METROPOLITAN GOVERNMENT OF NASHVILLE AND DAVIDSON COUNTY

Metropolitan Historic Zoning Commission
Sunnyside in Sevier Park
3000 Granny White Pike
Nashville, Tennessee 37204
Telephone: (615) 862-7970
Fax: (615) 862-7974

STAFF RECOMMENDATION
1401 Dallas Avenue
October 17, 2012

Application: Demolition-partial; New construction – addition
District: Belmont-Hillsboro Neighborhood Conservation Zoning Overlay
Council District: 18
Map and Parcel Number: 11801005800
Applicant: Blaine Bonadies, architect
Project Lead: Michelle Taylor, michelle.taylor3@nashville.gov

left elevation

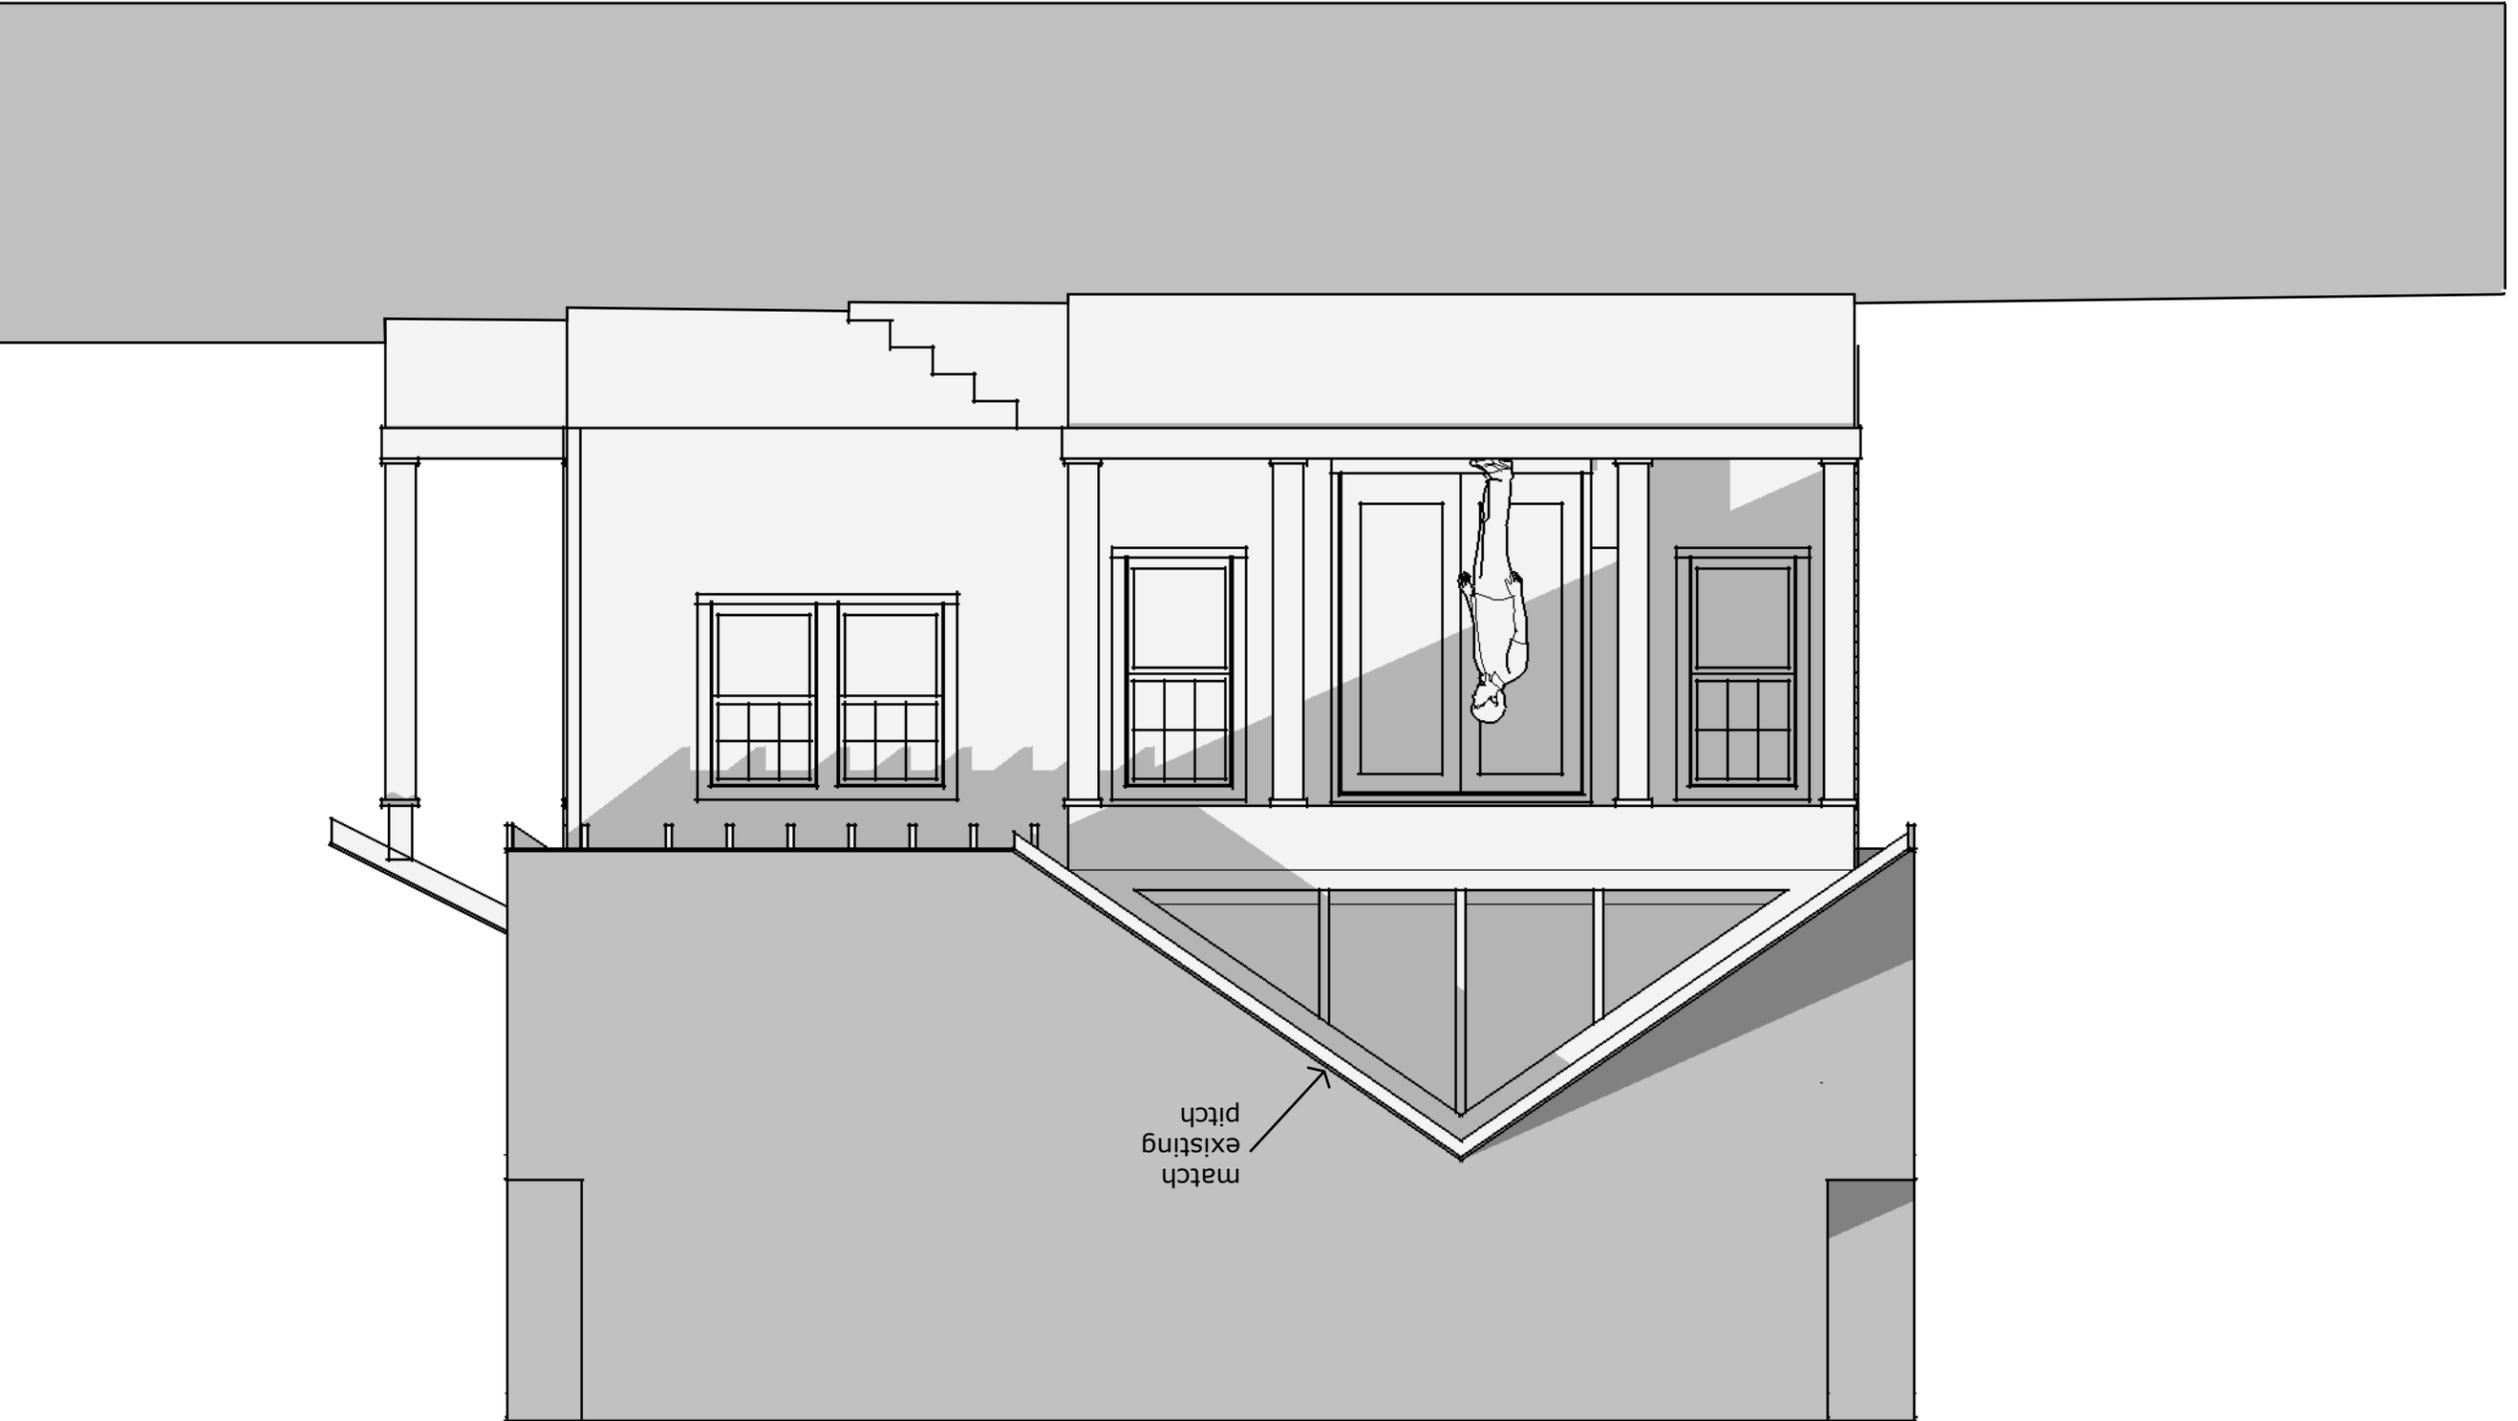
However, the left side of the addition will step out four feet (4') from the rear corner of the historic house, carry back eight feet (8'), before stepping back out in line with the wall of the house for another seventeen feet, eight inches (17'8"). Per the design guidelines an addition should be situated in such a way that will not disturb either the front or side facades and should be distinguishable from the historic structure. Except for specific conditions that this project does not meet, the Commission has always required rear additions inset one foot for each story from the side wall. When an addition needs to be wider than the existing house, it should not wrap the rear corner, as this alters the form of the house and makes it more difficult to remove the addition at a later date, if desired, another condition of the design guidelines. As proposed, the left side of the addition will not inset from the side wall but rather step out four feet (4') from the rear corner. Also, this portion of the addition will be covered and subsequently clip the corner of the existing side-gabled roof.

Because the addition is not inset on the left side which will subsequently compromise the rear corner and form of the house as well as the roof form, is not easily removable, and does not meet the standard developed to keep additions subordinate to primary buildings, staff recommends that the addition have the required one-foot inset.

- The addition sit in a minimum of one foot (1') on each side; and
- Staff provide final review of windows and doors, porch steps and roof color.

right side elevation

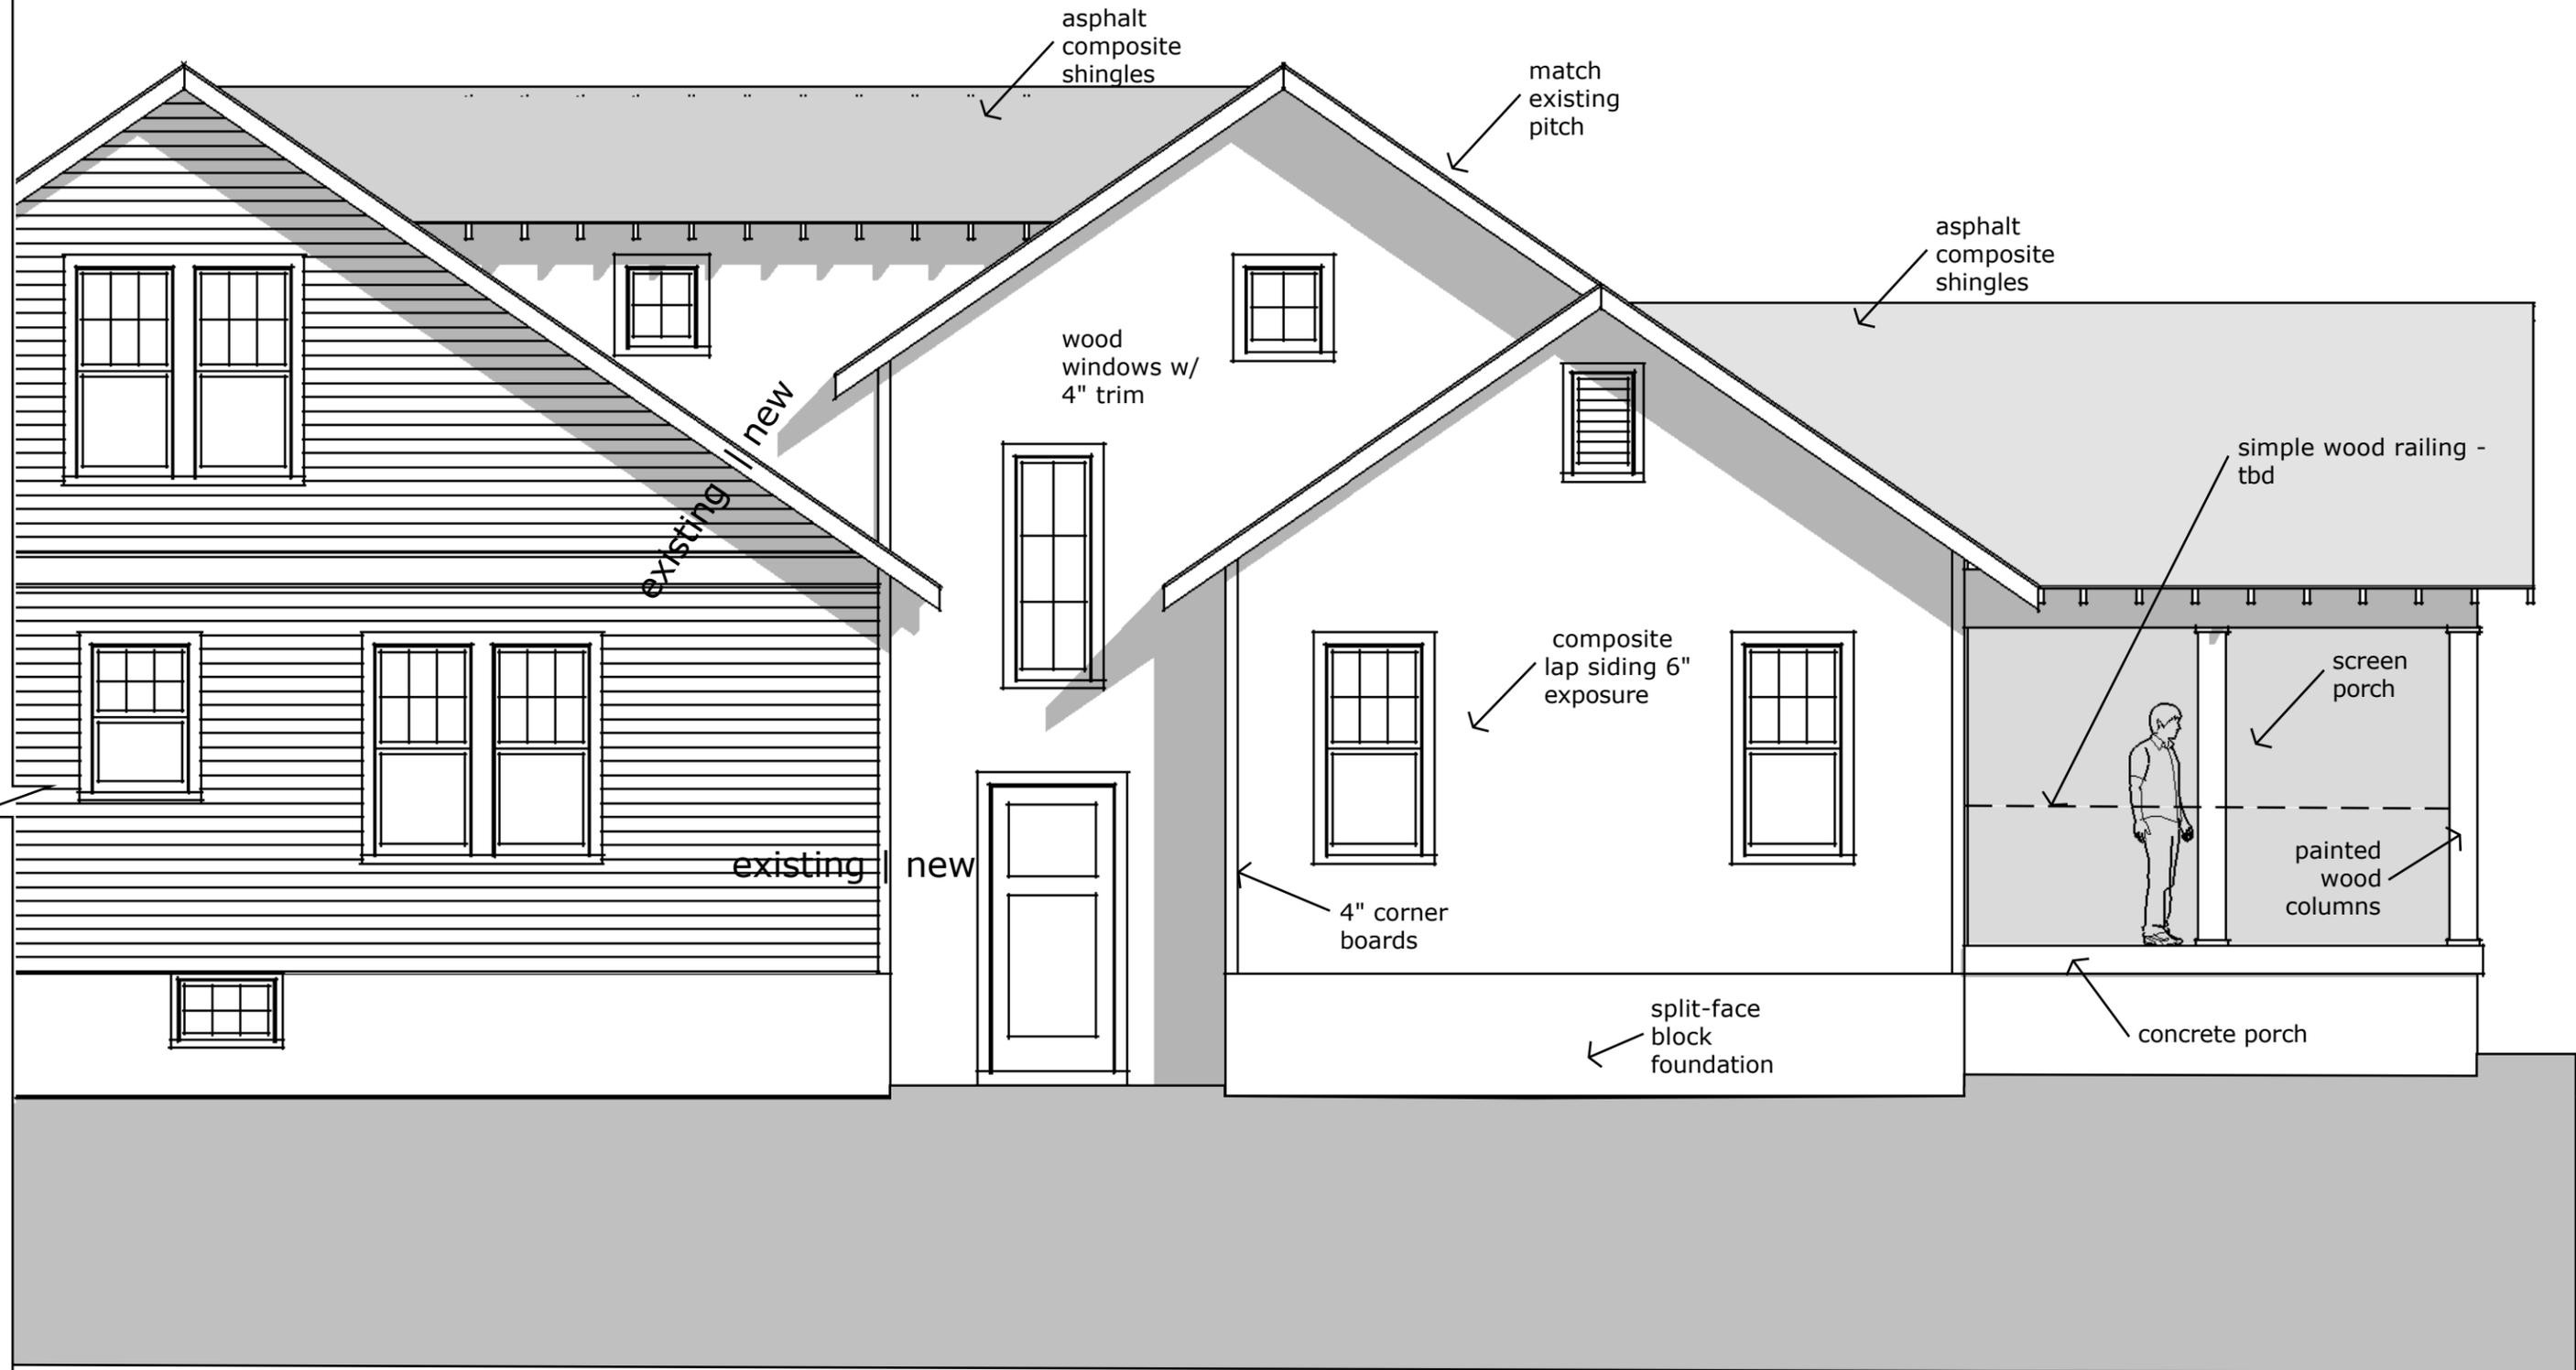
Location and Setback: The addition meets all bulk zoning requirements for setbacks. The right wall of the addition will step in two feet, two inches (2'2") from the historic house, carry back eight feet (8'), and then step back out for another thirty feet (30'). This depth includes a twelve foot, four inch (12'4") rear covered screened porch.
